St. Johns River Water Management District

SUBJECT: Addendum #4 to Quote Request, # 37728, Install new 60-inch Aluminum Flap Gate on S-259 Discharge Pipe

Original Drawings S-259 Flap Gate

FLAP GATE OPERATING DEVICE
 SCALE: "B"

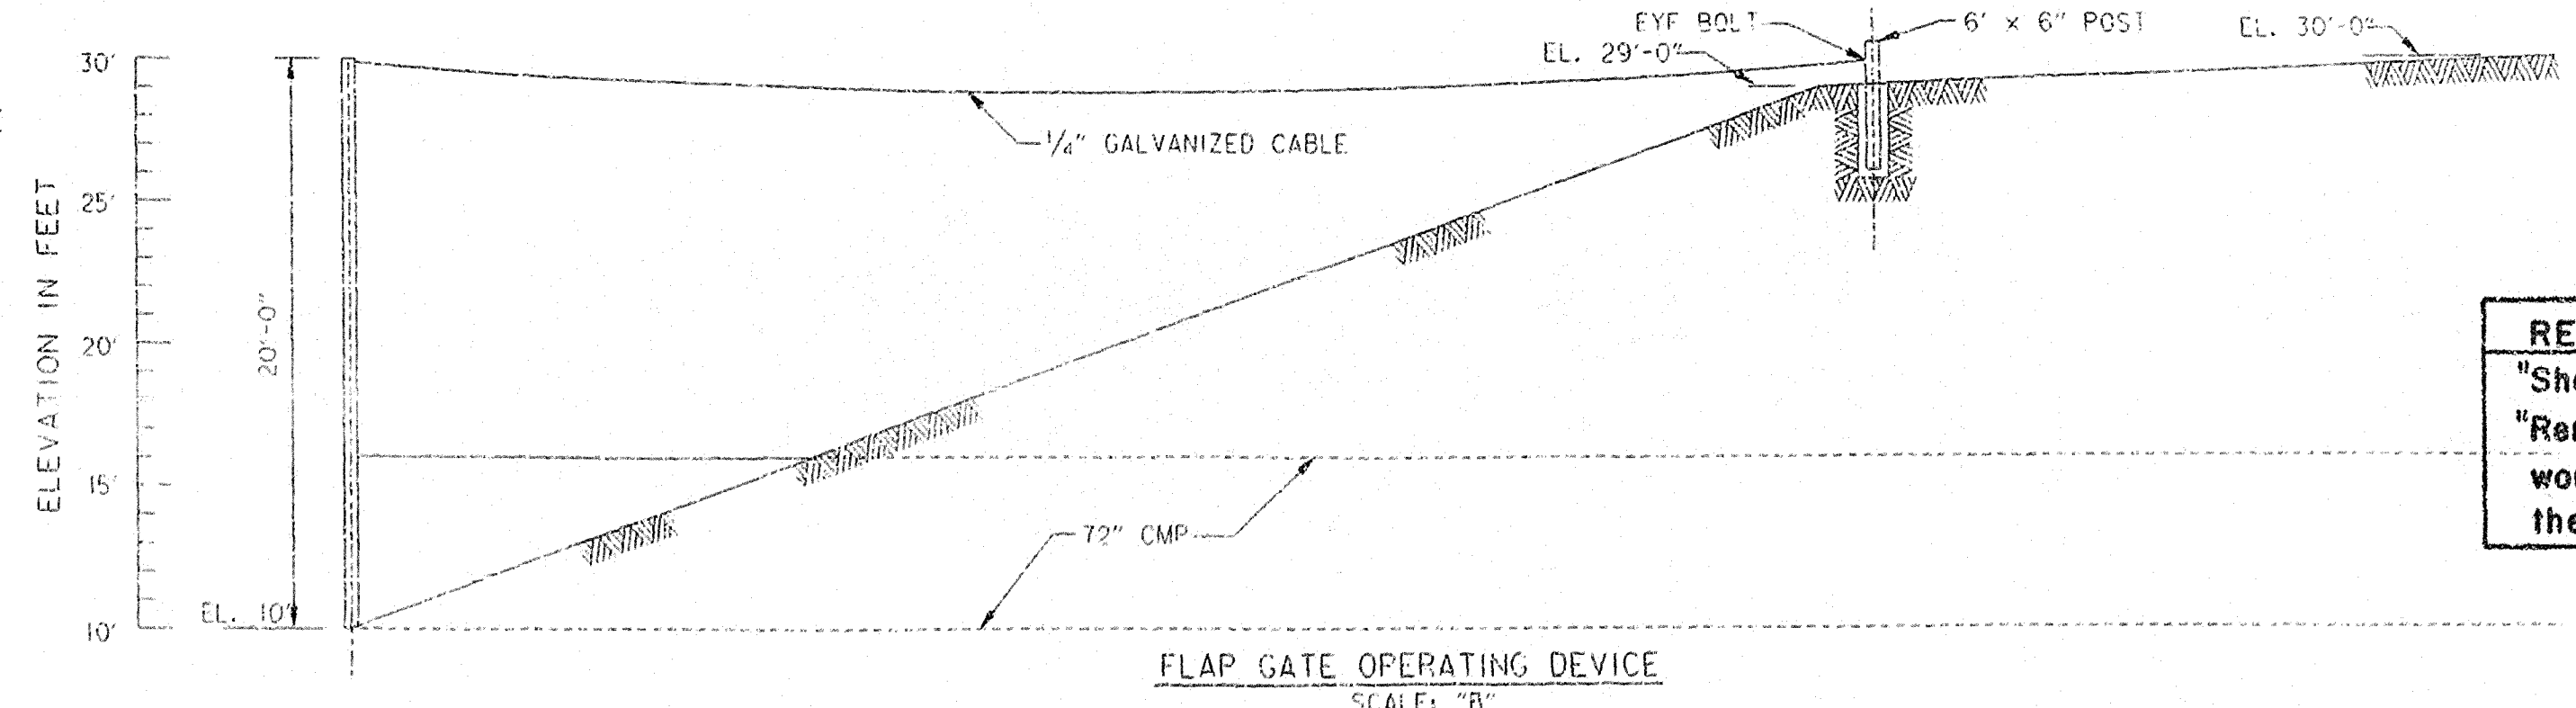
- Q2: Is the existing South flap gate constructed and installed the same way as the construction drawings? Can you please provide the contact information for the manufacturer of that gate?

- Q8: The bid documents call for installation of a "structural member" to be attached to the walkway piles. I see in the report provided in addendum 3 that the piles are timber. Can you please tell us the diameter of the piles and the distance on center between piles? What material do you want the structural member made of?

- A2: The District does not have this information. The USACE was responsible for constructing this structure in the early 1990s. Attached are pertinent drawings/details from the original construction. The gate was manufactured for a 72-inch CMP and then retrofitted when sliplined in 2016.

- A8: The piles are 18-inch diameter piles, the structural member(s) shall be aluminum. See details of existing flap gate construction on attached drawings.

CULVERT GATE ATTACHMENT RING
SCALE: 'B'

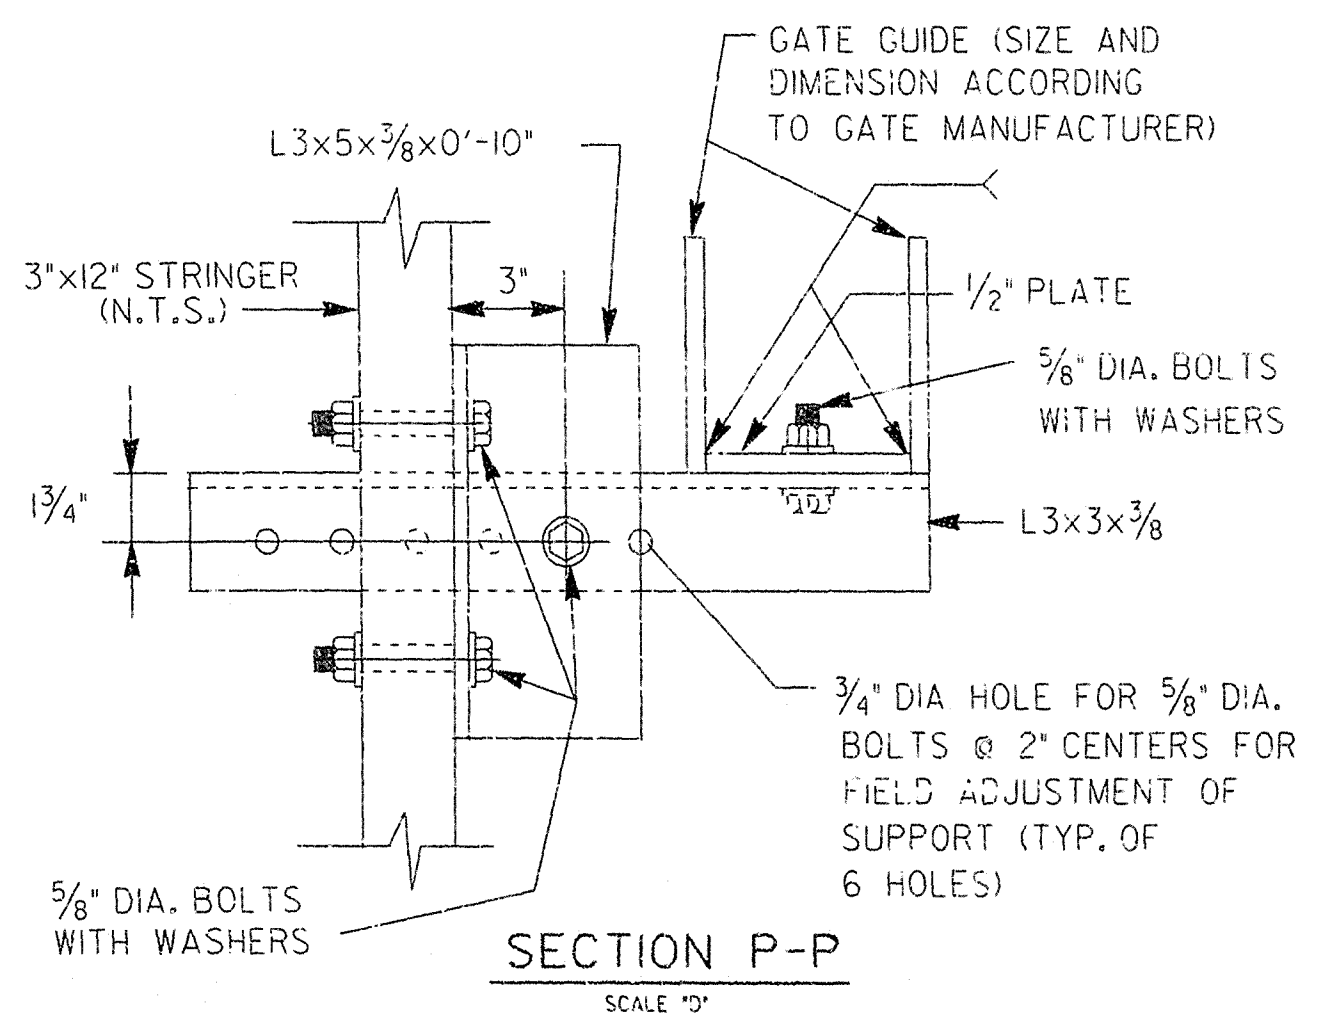
- Q10: Will the ¼" thick aluminum sleeve need to be coated on the outside where it is in contact with the grout? Many EORs do not like to have aluminum in direct contact with cementitious materials.

- A10: The District has no issues with the aluminum coming in contact with the cementitious materials used for grouting, there is no requirement for coating the outside of the aluminum sleeve.
